T-MOBILE OFFICE BUILDING

MAJOR SITE PLAN AMENDMENT

COVER SHEET

SITE PLAN
 T-MOBILE OFFICE BUILDING - MAJOR SITE PLAN AMENDMENT
 LOT 1, BLOCK 2 TOWER CENTER FOR INDUSTRY SUBDIVISION FILING NO. 2
 SITUATED IN THE NE 1/4 OF SECTION 33, T.3S., R.66W. OF THE 6TH P.M.
 CITY OF AURORA, COUNTY OF ADAMS, STATE OF COLORADO

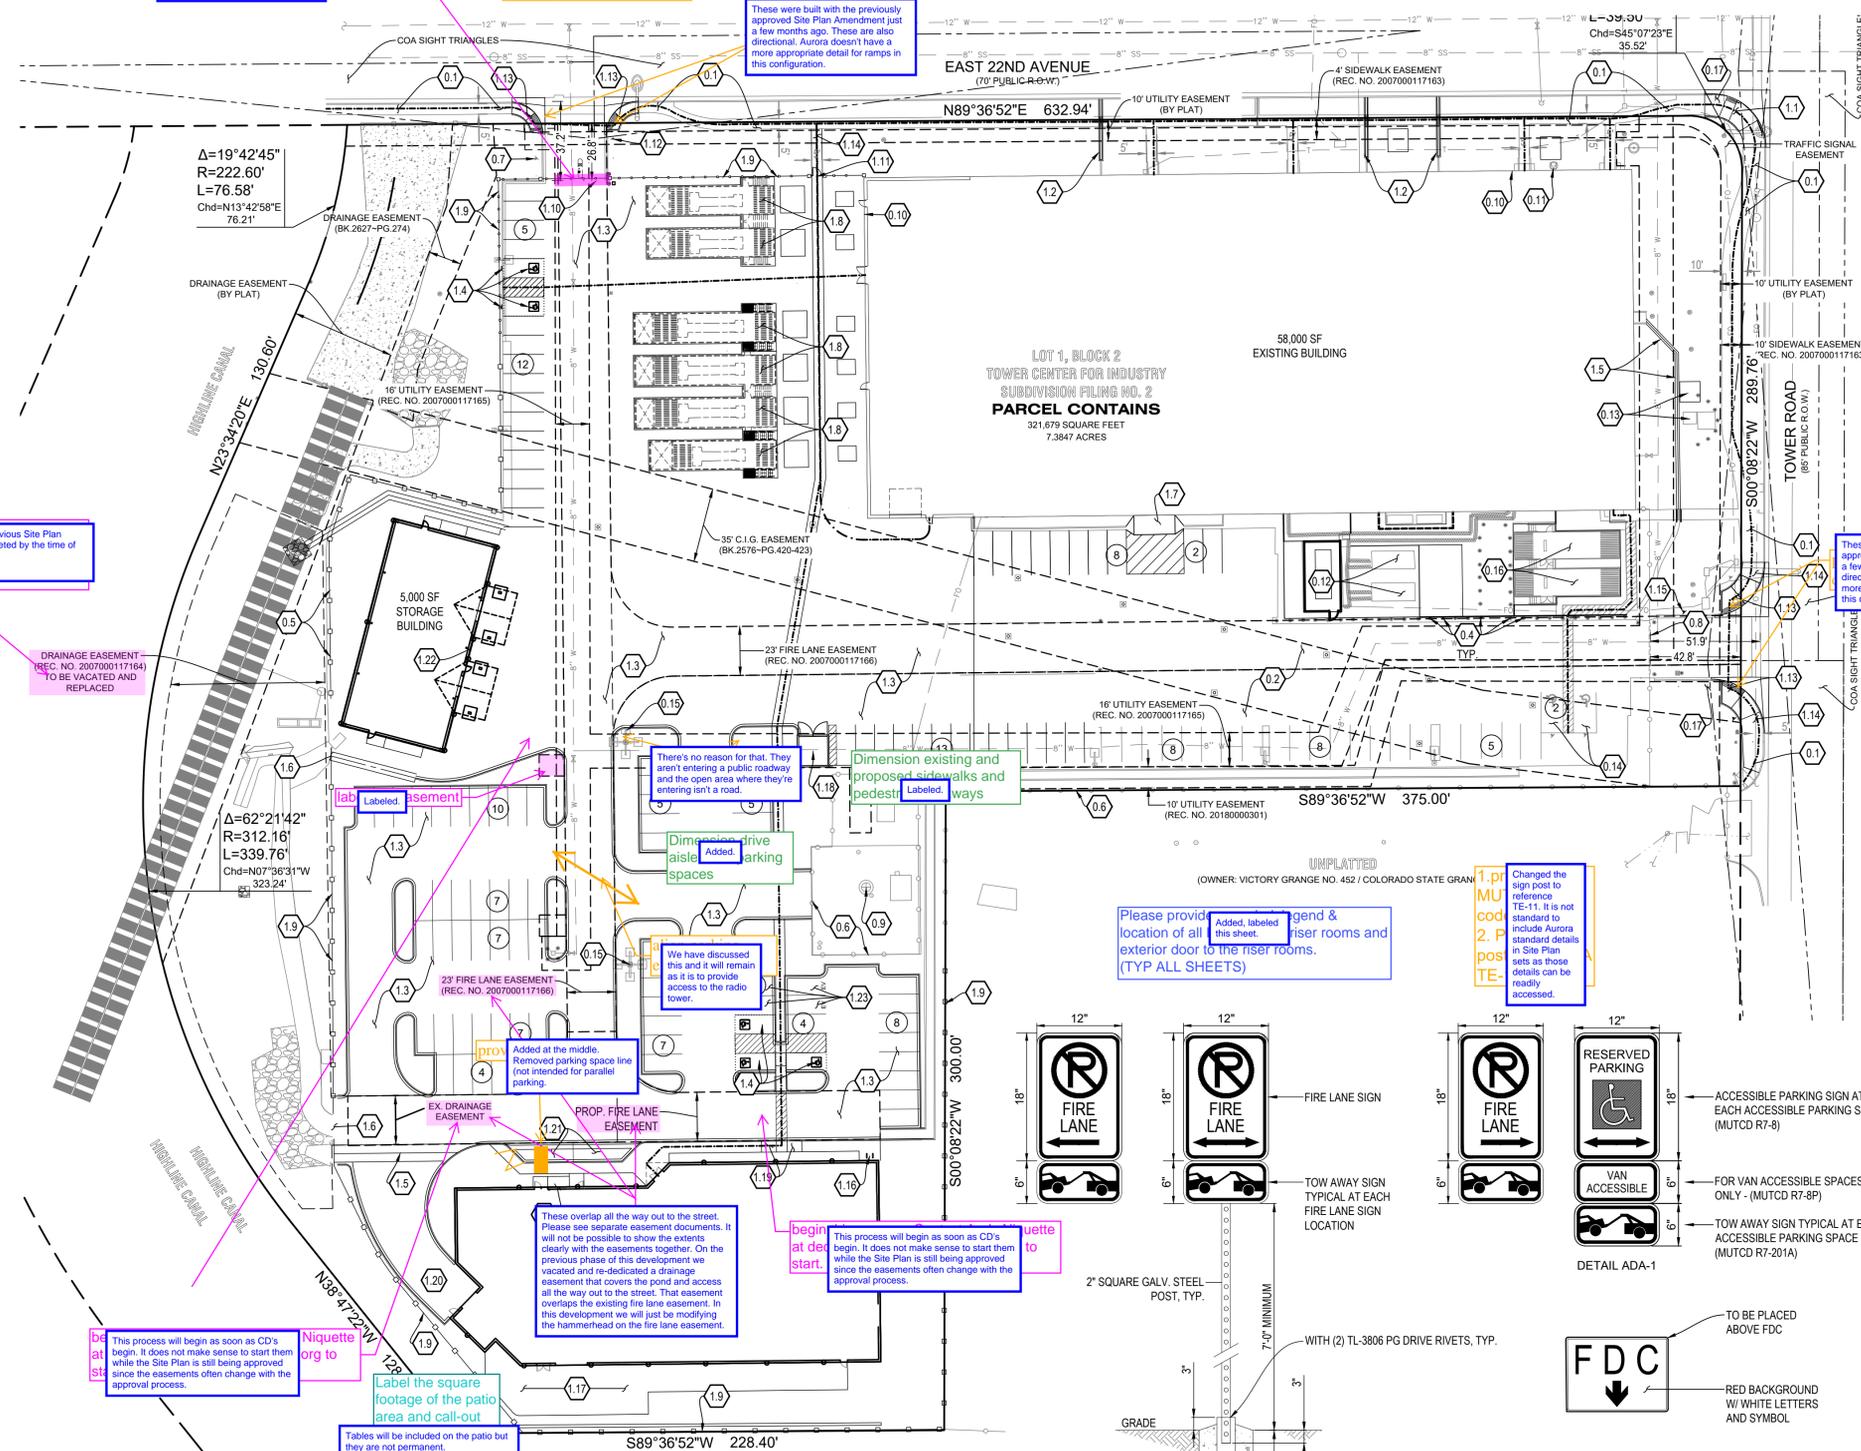
Several comments throughout are requests (fence, For clarification add a sheet & the request details there.

GRADING AND UTILITY PLAN
T-MOBILE OFFICE BUILDING - MAJOR SITE PLAN AMENDMENT
LOT 1, BLOCK 2, TOWER CENTER FOR INDUSTRY SUBDIVISION FILING NO. 2
SITUATED IN THE NE 1/4 OF SECTION 33, T.3S., R.66W. OF THE 6TH P.M.
CITY OF AURORA, COUNTY OF ADAMS, STATE OF COLORADO

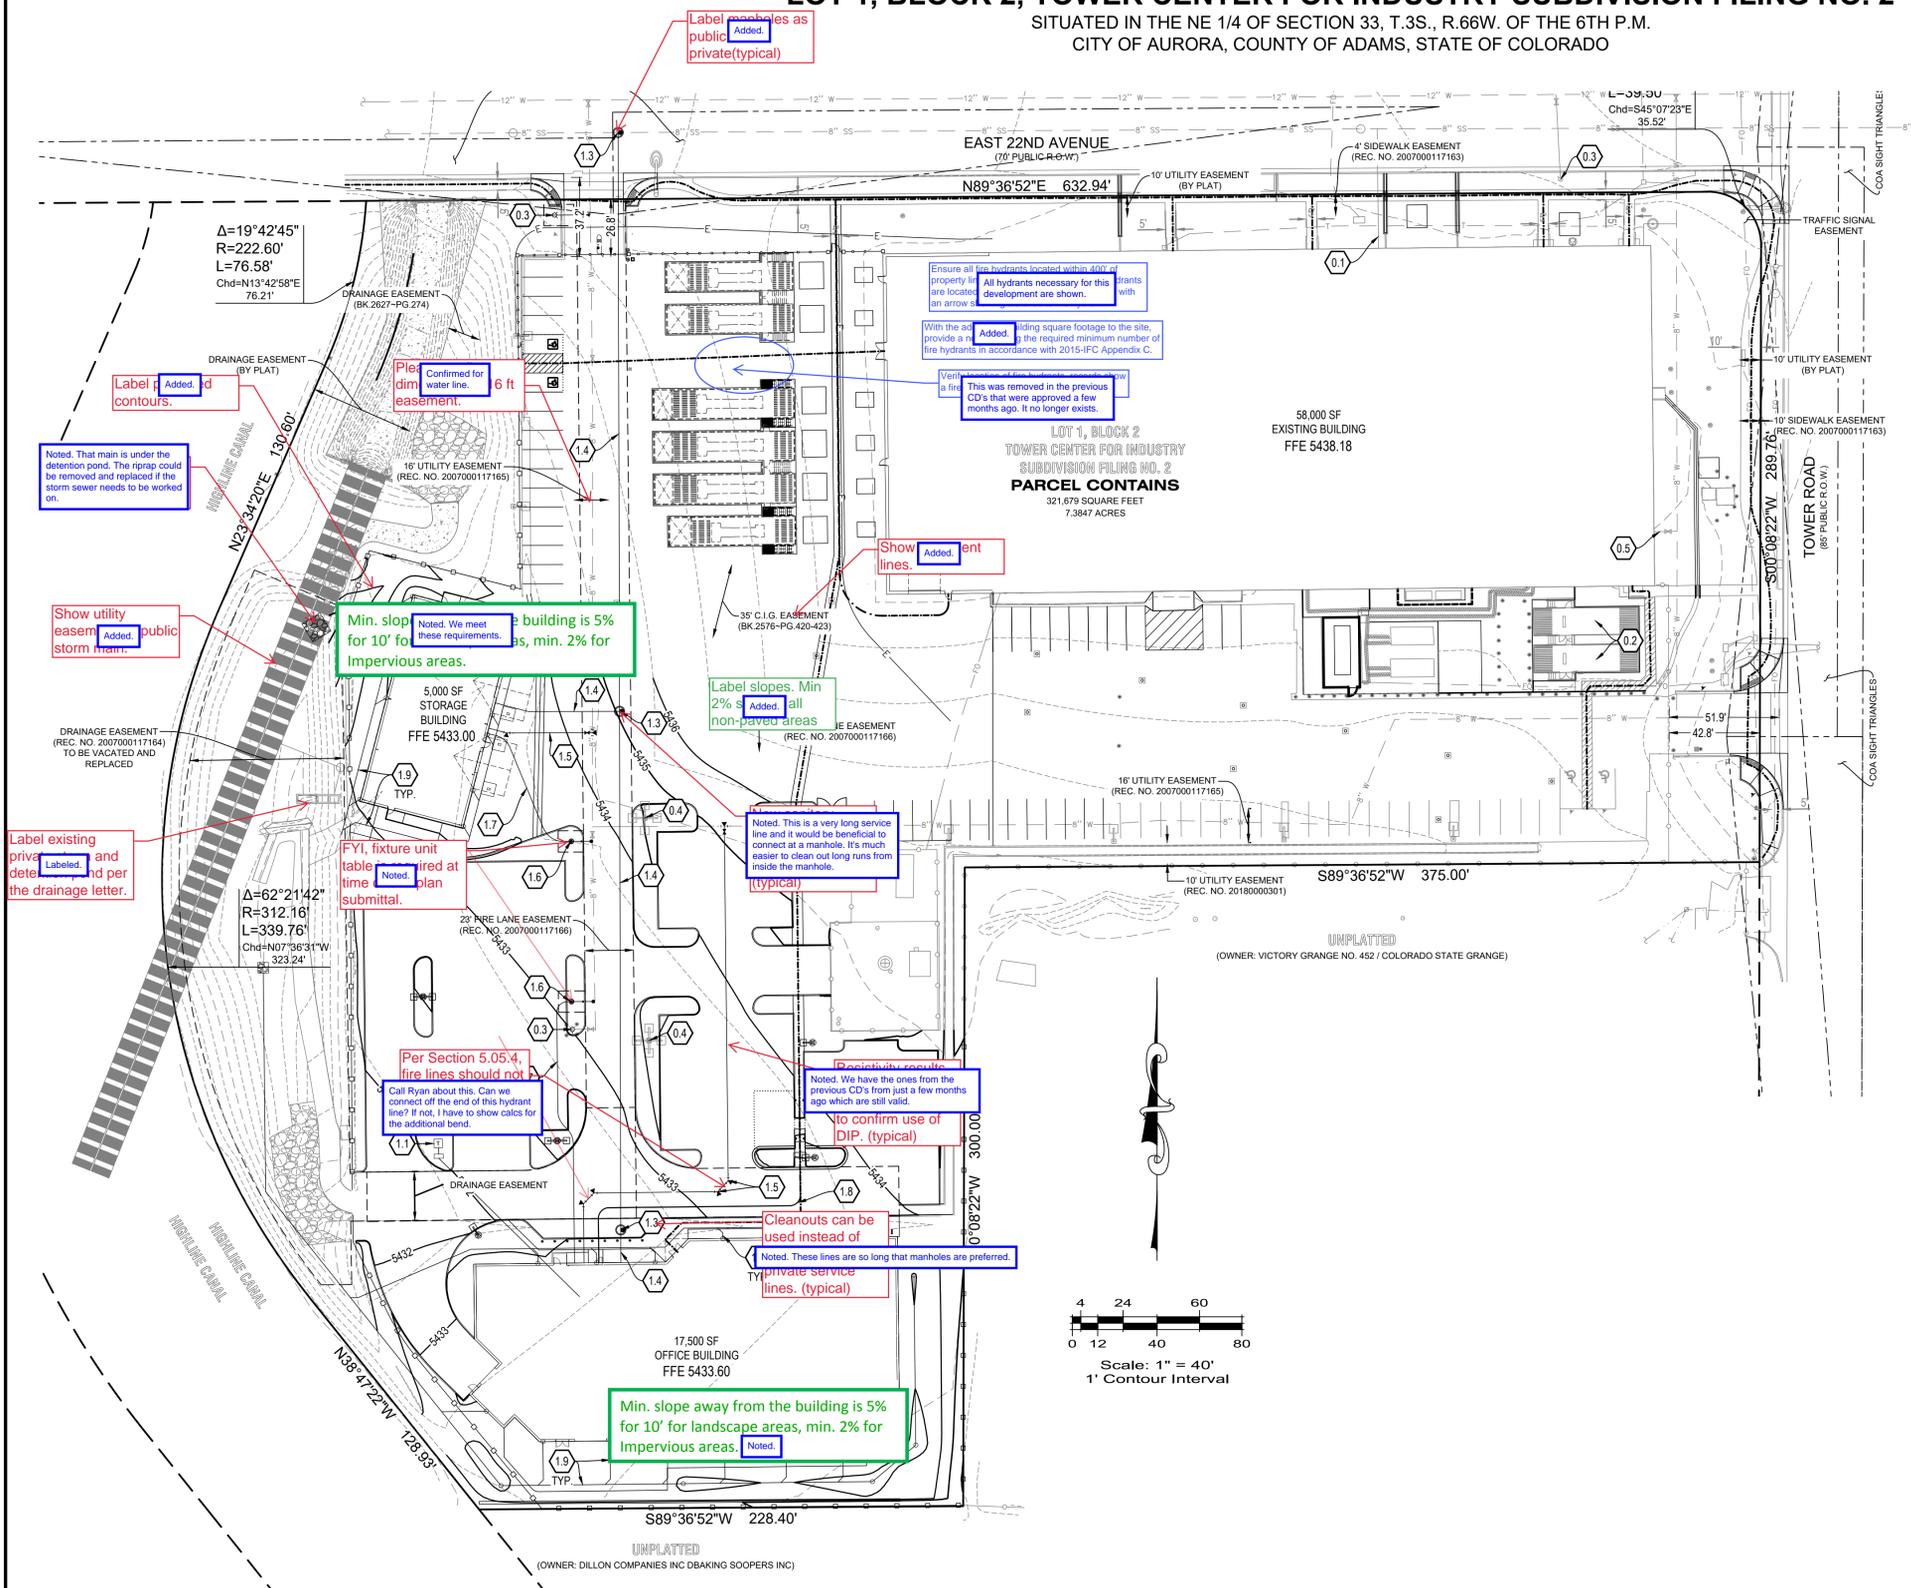
Add a n [All private. Added. if the storm sewer system is public or private and who will maintain it.

If thi [Labeled as private (all). Only the manhole on the public line will be public.

Label [Added. and contours.

Ensure all fire hydrants located within 400' of property line are located in accordance with 2015-IFC Appendix C.

With the addition of existing square footage to the site, provide a note indicating the required minimum number of fire hydrants in accordance with 2015-IFC Appendix C.

Verify a fire CD that was removed in the previous CD's that were approved a few months ago. If no longer exists.

Label slopes. Min 2% [Added. all non-paved areas

Show utility easement [Added. public storm drain

Label existing private [Labeled. and detention per the drainage letter.

FYI, fixture unit table [Noted. required at time of plan submittal.

Per Section 5.05.4, fire lines should not be [Noted. Call Ryan about this. Can we connect off the end of this hydrant line? If not, I have to show callouts for the additional bend.

To confirm use of DIP. (typical)

Cleanouts can be used instead of private service lines. (typical)

Min. slope away from the building is 5% for 10' for landscape areas, min. 2% for impervious areas. [Noted.]

Noted. That main is under the detention pond. The riprap could be removed and replaced if the storm sewer needs to be worked on.

All hydrants necessary for this development are shown.

Noted. This is a very long service line and it would be beneficial to connect at a manhole. It's much easier to clean out long runs from inside the manhole.

[Positive results. Noted. We have the ones from the previous CD's from just a few months ago which are still valid.

Noted. These lines are so long that manholes are preferred.

LANDSCAPE IMPROVEMENTS

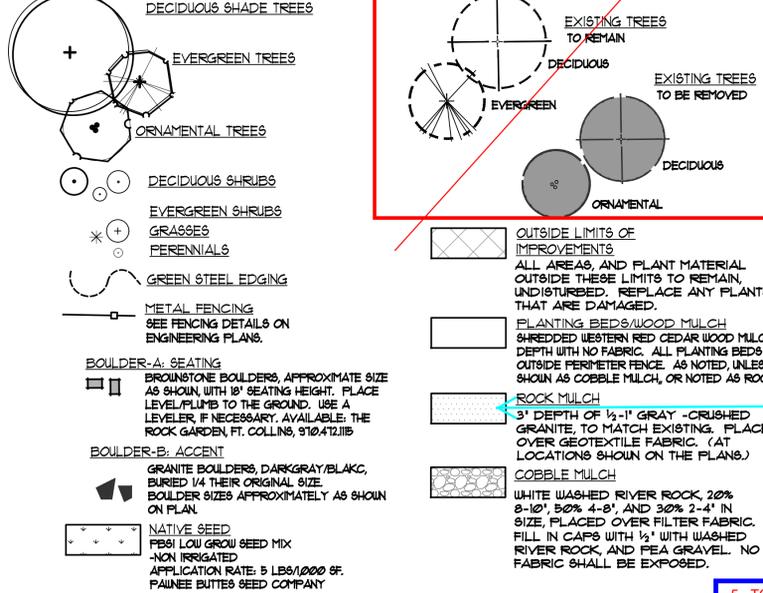
Add this same legend/symbology to the tree mitigation plan for reference.

Technically code requires buildings that face open space (i.e. the Highline Canal) to have building perimeter landscaping. The length of the building would require two trees. These trees may count toward that requirement. Update the landscape table accordingly.

This is not showing up here or on the plan very well. Too light in color.

Add an asterisk and a note at the bottom of the table that states that one extra tree is provided API - B that is being used toward tree mitigation.

Shrubs are not permitted to be used as a substitute for trees in the buffer unless the buffer is encumbered i.e. easements, floodplain etc.

No more than 20% of the total shrub count may be ornamental grasses used to satisfy the buffer requirement.

Perennials may not be used to satisfy the buffer requirement. They may be used as accents only.

Each of the buffer requirements shall be met independently. Shifting plant material does not meet code requirements. If the buffer can not be met, ask for an adjustment and express a hardship. Staff however is not in support of an adjustment as changes can be made to the layout to account for the correct buffer width and plant material.

A 25' wide Special Landscape Buffer with 1 tree and 10 shrubs per 25 linear feet along the boundary should be provided adjacent to the High Line Canal. Clearly label/identify the proposed landscape material.

These are trees that can be used toward mitigation UNLESS adjustments are being requested in which case they may need to be used to mitigate or offset the adjustment request.

provide sight triangles at parking lot egresses and verify landscaping is in compliance with COA Roadway Specifications, Section 4.04.2.10

Parking lot islands can not be all ornamental grasses. Only 30% for the total required plant count. So two for a small parking lot island.

Dimension the buffer being provided

These plants for the buffer are supposed to attain a minimum height of between 4'-5'

Too many grasses

Too many grasses

What is this line running along here and can it be turned off?

Update the table. See comment above on the actual landscape plan for the proposed storage building.

1. LEGEND HAS BEEN ADDED TO MITIGATION PLAN

3. BUILDING SIDE, FACING OPEN SPACE, IS ACTUALLY 100 FT. LONG, REQUIRING 2.5 TES. PLAN HAS BEEN REVISED AND TABLE HAS BEEN ADDED.

4. CHANGED TO A DARKER COLOR, AND A MORE CONDENSED HATCH PATTERN

5. TO IDENTIFY TREES THAT ARE BEING PROPOSED FOR MITIGATION OF MISSING/REMOVED TREES, THOSE LABELS HAVE BEEN BOXED IN, AS SHOWN AND DESCRIBED UNDER PLANT LEGEND, AND NOT COUNTED UNDER ANY OF THE REQUIRED CATEGORIES.

11. ACKNOWLEDGED

12. HAVE BEEN CHANGED

13. ACKNOWLEDGED

17. PIPE WAS MOVED TO THE EAST

16. ACKNOWLEDGE AND DONE AS REQUESTED

2. TREES THAT ARE INTENDED TO SERVE AS MITIGATION REPLACEMENTS ARE BOXED IN, AS NOTED ON THE PLANT SCHEDULE.

25. THIS IS A PRIVATE, FENCED, INTERIOR PARKING LOT

24. GRASS NUMBERS HAVE BEEN REDUCED

23. DIMENSION IS NOW SHOWN

22. MISLABELED. SHOULD BE MOONGLW JUNIPERS

24. REDUCED

24. REMOVED

21. LODENSE PRIVET WAS CHANGED TO CHEYENNE PRIVET, PROVIDING A 6-8FT. SCREEN. THERE IS AN 8FT. SOLID FENCE AROUND PERIMETER OF SITE

20. IT IS A MAJOR CONTOUR LINE

19. TWO SECTIONS ARE INCLUDED

18. BUFFER DIMENSIONS ARE NOW SHOWN, AND TABLE CALCULATIONS HAVE BEEN ADJUSTED

14. TABLE FOR STORAGE PERIMETER LANDSCAPE HAS BEEN UPDATED

4 TREE PROTECTION

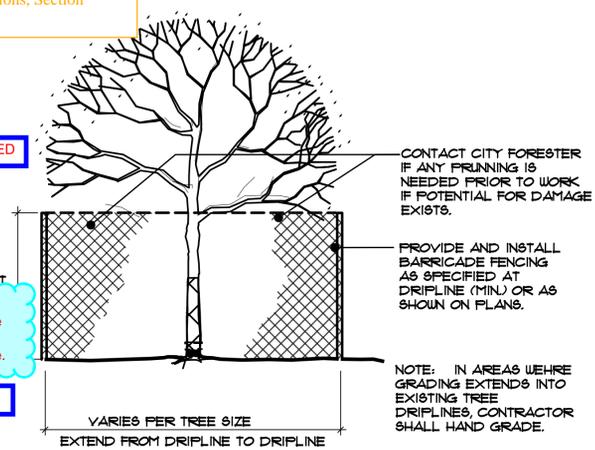
including COA Roadway Specifications, Section 4.04.2.10

Typo

Remove any reference to the previous landscape code.

Provide a detail of the proposed fence. Include the material, height, color etc.

Provide a detail of the proposed retaining wall. Staff does not have access to civil drawings.

2. NOTE ADJUSTED

3. CORRECTED

4. REMOVED

1. FENCE AND WALLS NOT BEING PROPOSED UNDER THE LANDSCAPE SCOPE OF WORK. THOSE DETAILS ARE SHOWN ON THE CIVIL ENGINEERING PLANS.

SITE PHOTOMETRIC PLAN
Scale: 1"=30'

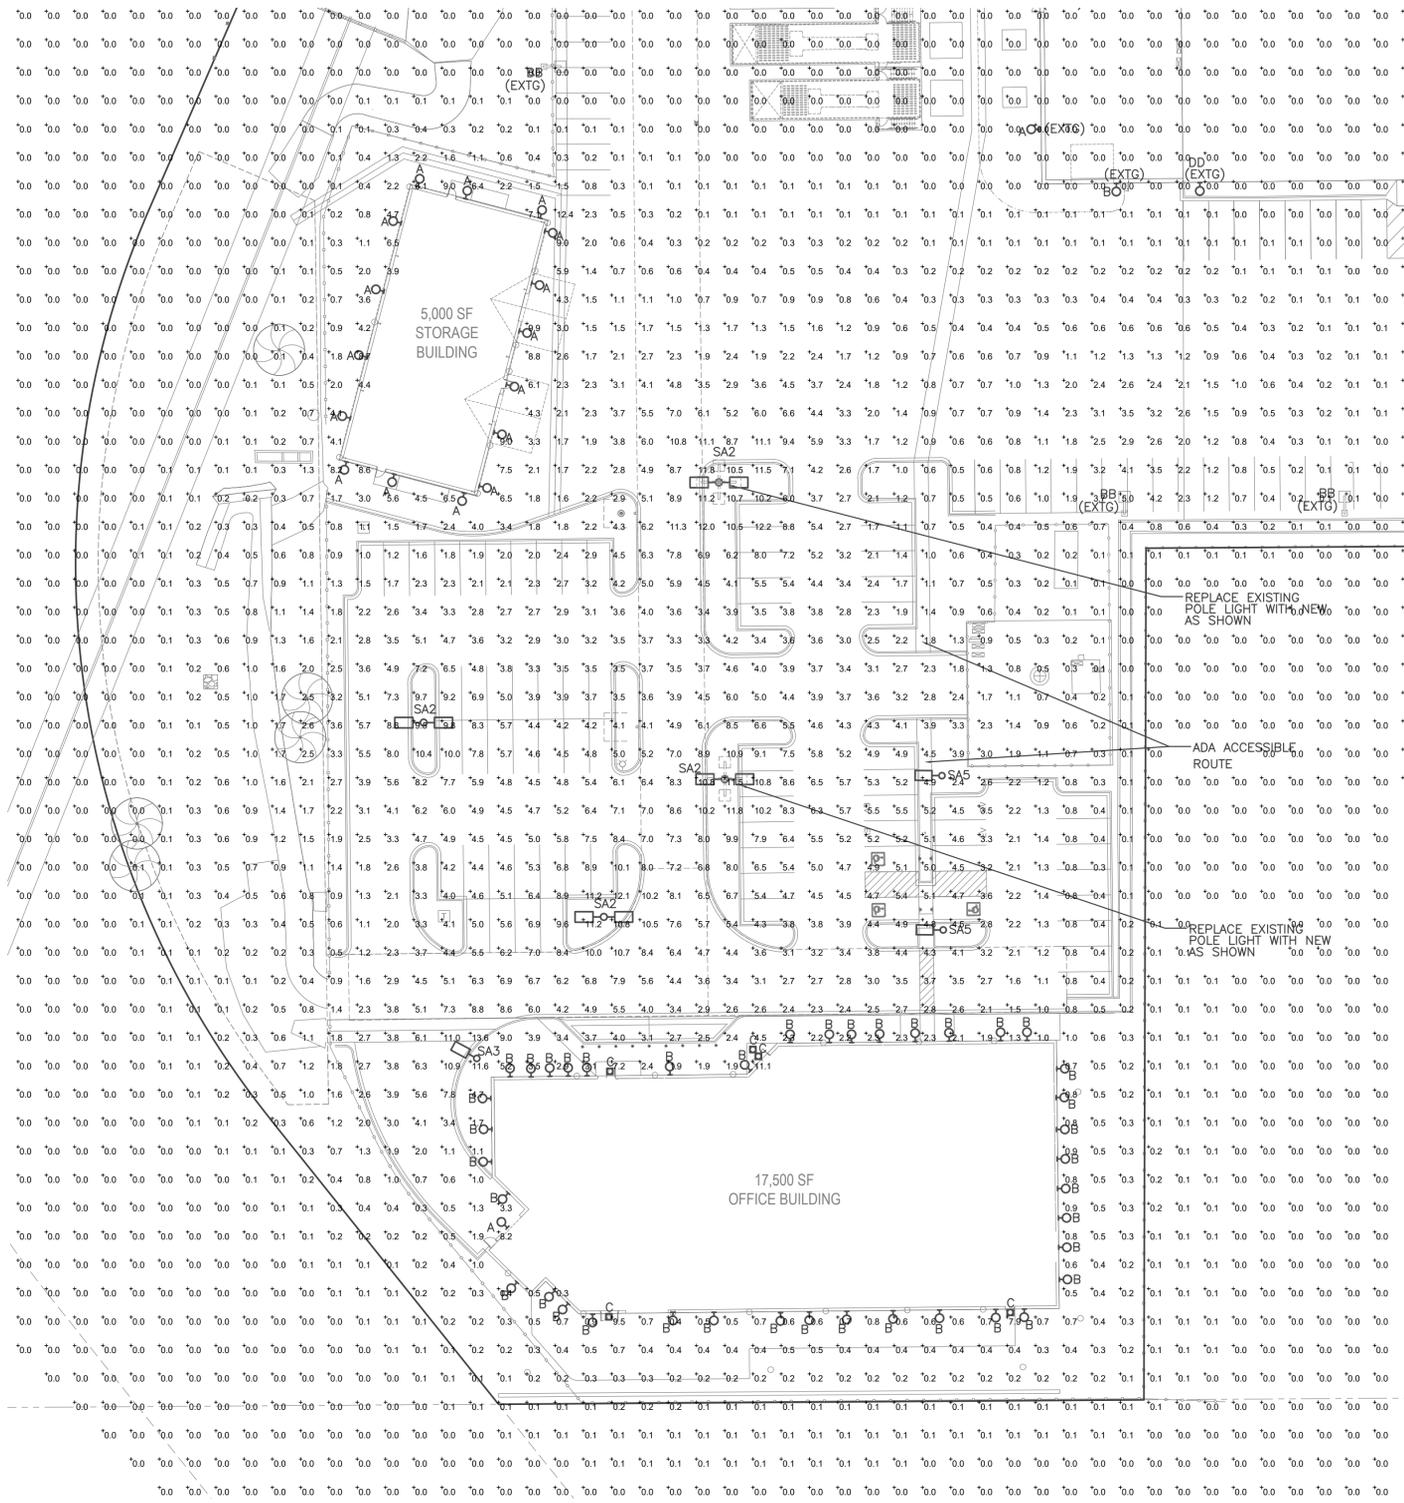
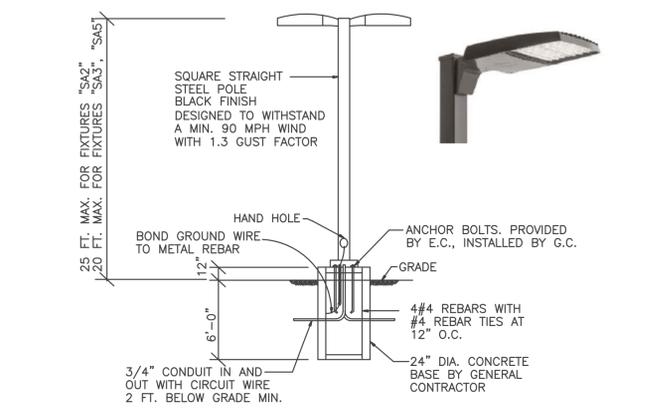
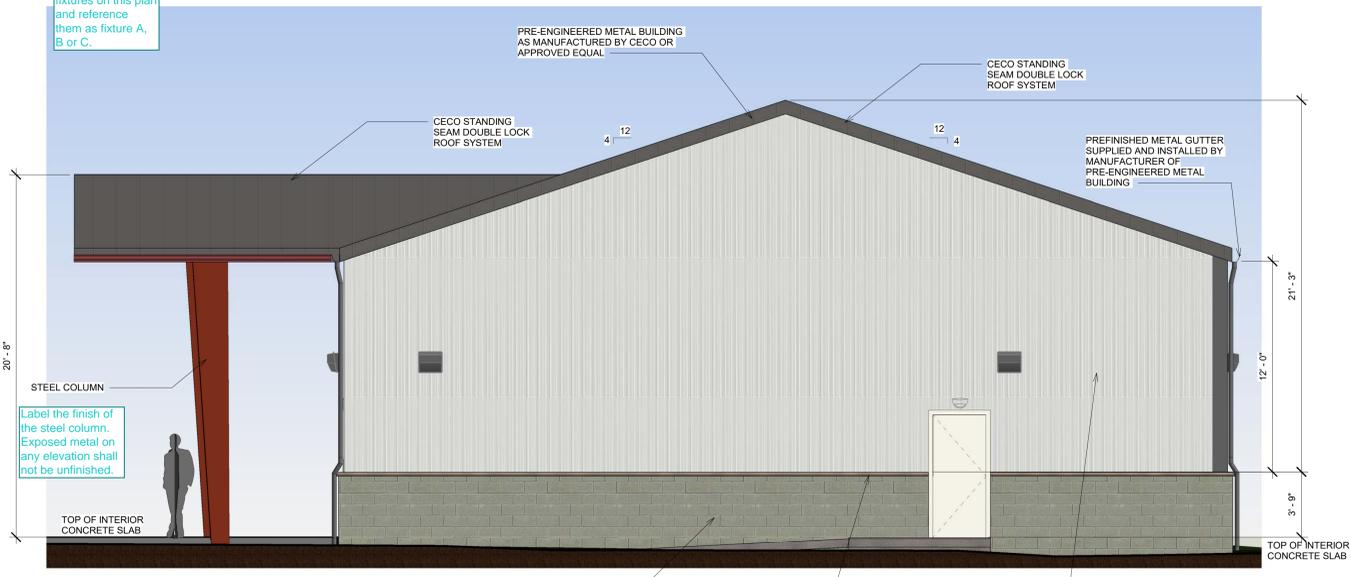
Ensure fixture B is full-revised. It does not extend light in an upward direction.

Call out light fixtures on this plan and reference them as fixture A, B or C.
